ADDENDUM NO. 6
To the Contract Document and Project Specifications for the
Wayne High School Campus Improvements
Fort Wayne Community Schools (FWCS)
Fort Wayne, Indiana
November 18, 2025

The items in this addendum are to become a part of the original documents as if included therein. The remainder of the original contract document is to remain in its entirety. This Addendum modifies the Contract Documents and Specifications as follows:

L1.3

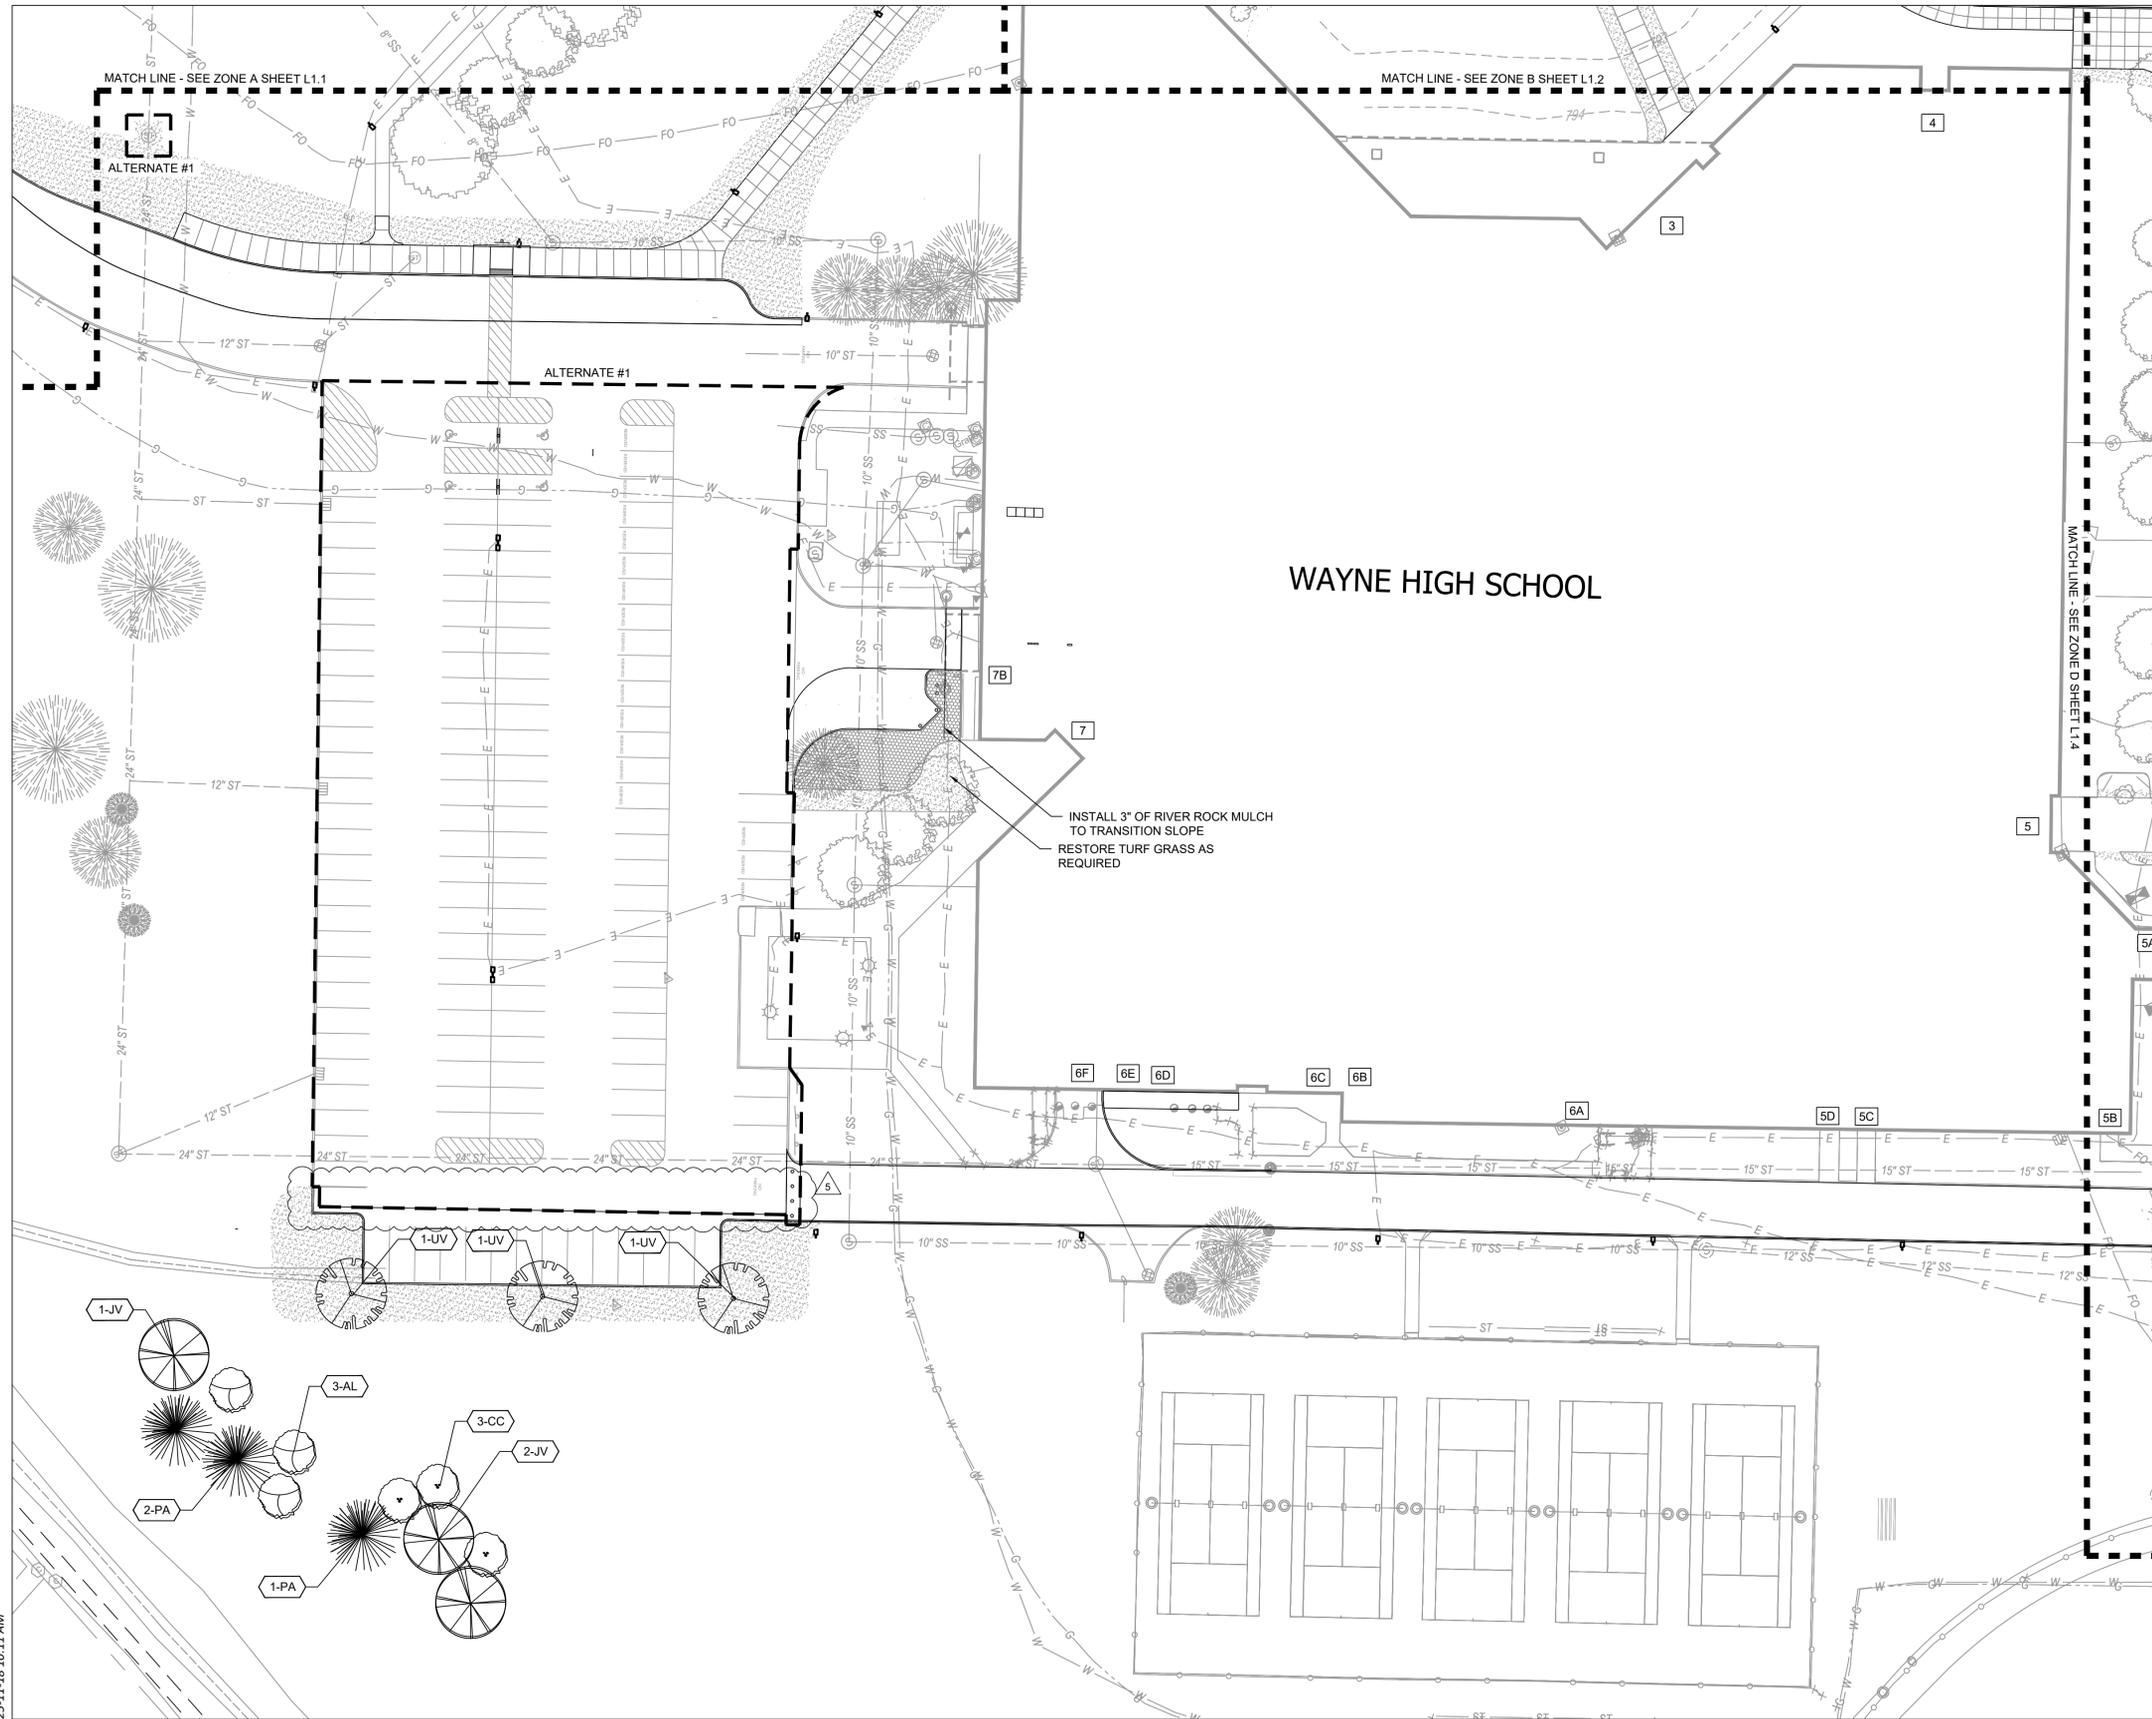
5. Plan Sheet L1.3 – Site Landscapae Plan – Zone C
Revised: Alternate #1 boundary

L1.4

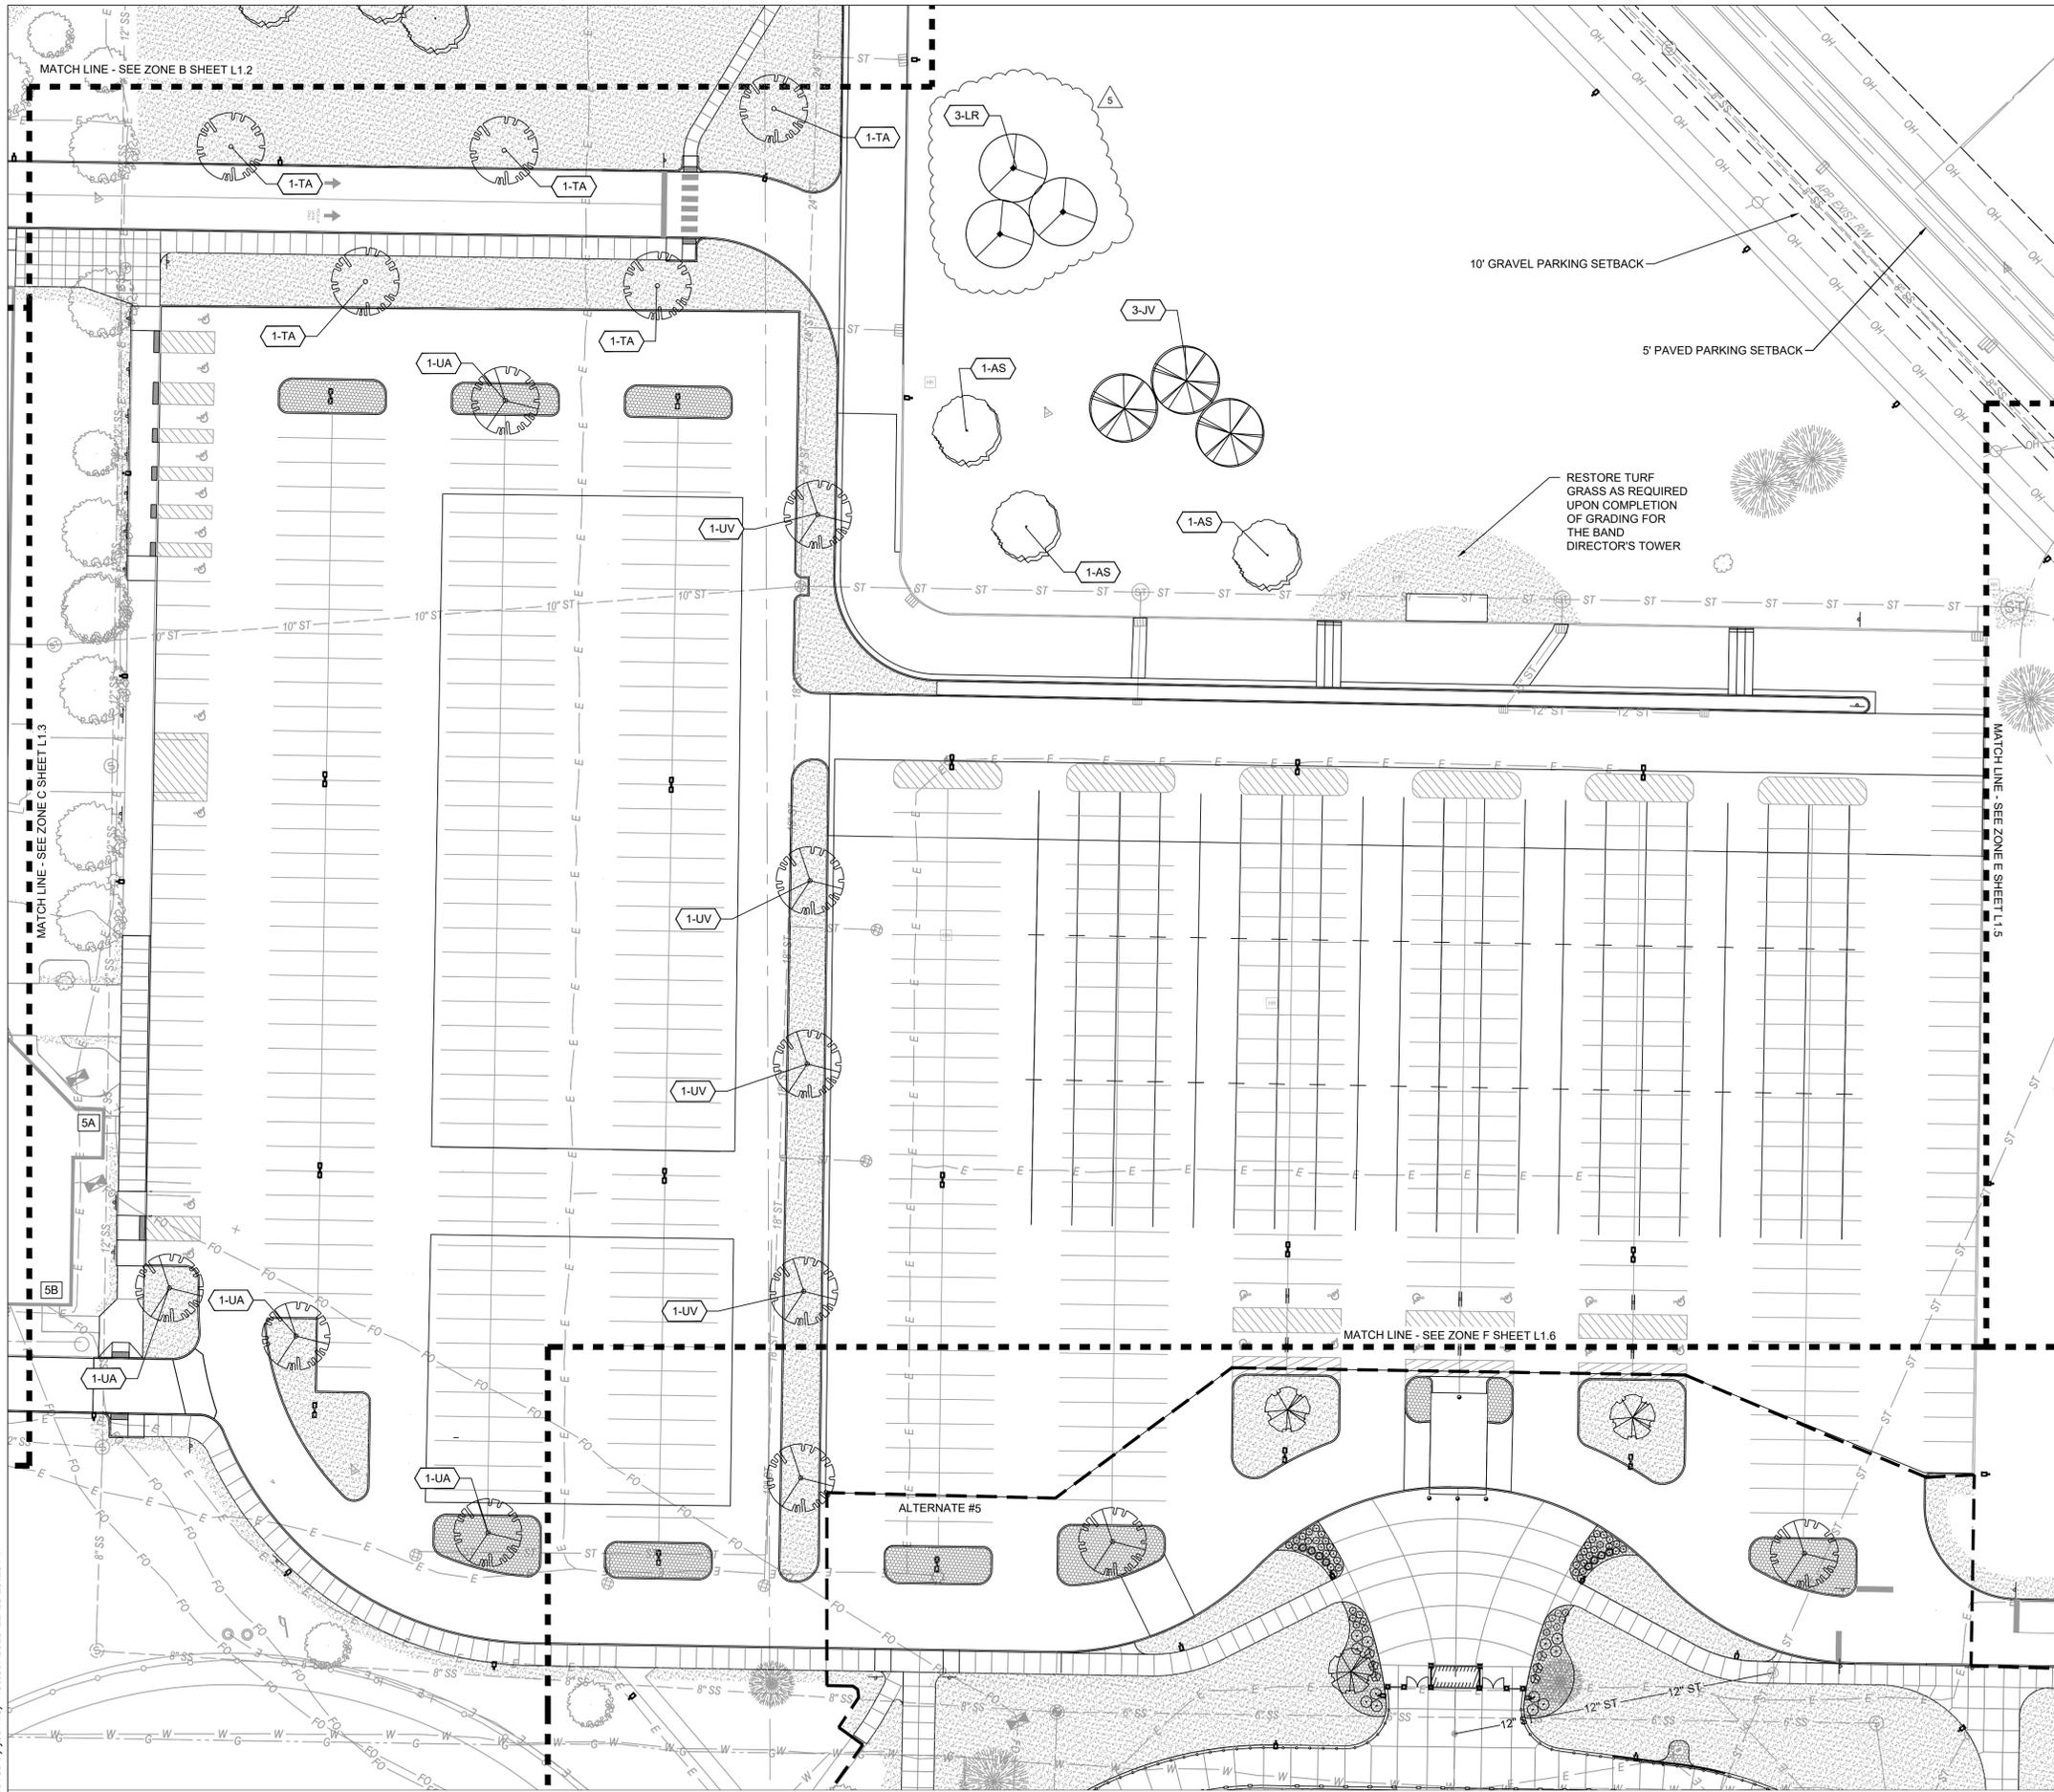
6. Plan Sheet L1.4 – Site Landscape Plan – Zone D
Revised: Grouping of trees to be “3-LR”
